# SERVICE BULLETIN

M-1073A

OCTOBER 12, 1998

## TOUR-PAK LID GASKET MODIFICATION

Figure 1.

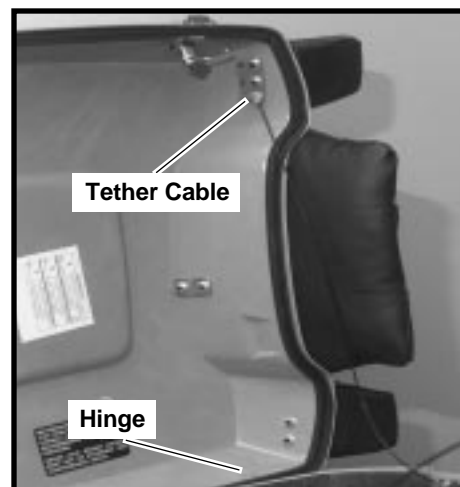
1. Refer to applicable Service Manual and remove Tour-Pak lid hinge pins and tether cable (Figure 1). Place lid upside down on a surface that will provide suitable paint protection.

Figure 2.

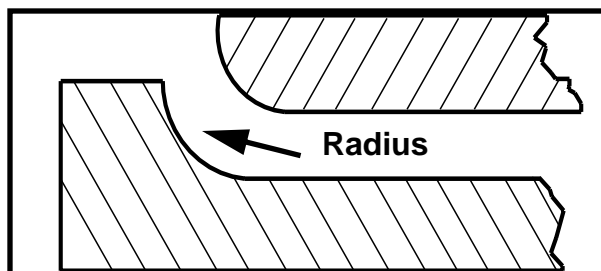
6. See Figure 2. Distribute a thin coat of adhesive to both a supplement gasket section and to radius of existing gasket in which supplemental gasket will be applied.

Figure 3.

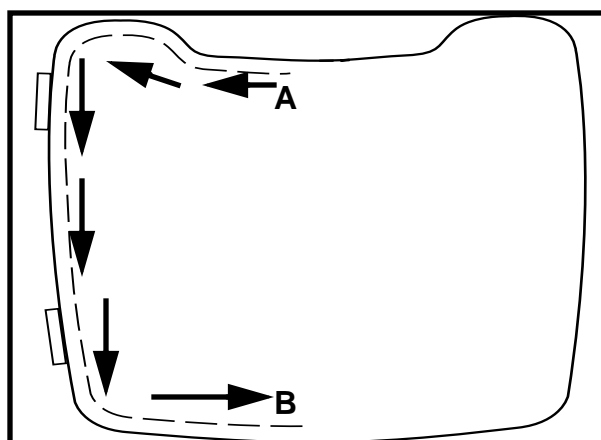
7. Refer to Figure 3. Starting at point (A), form supplemental gasket section into radius (Figure 2) of existing gasket stopping a point (B). Trim gasket using razor blade or other suitable cutting tool to obtain a uniform front to back seal. Do NOT stretch supplemental gasket section. Allow the gasket section to lay naturally on the existing gasket.
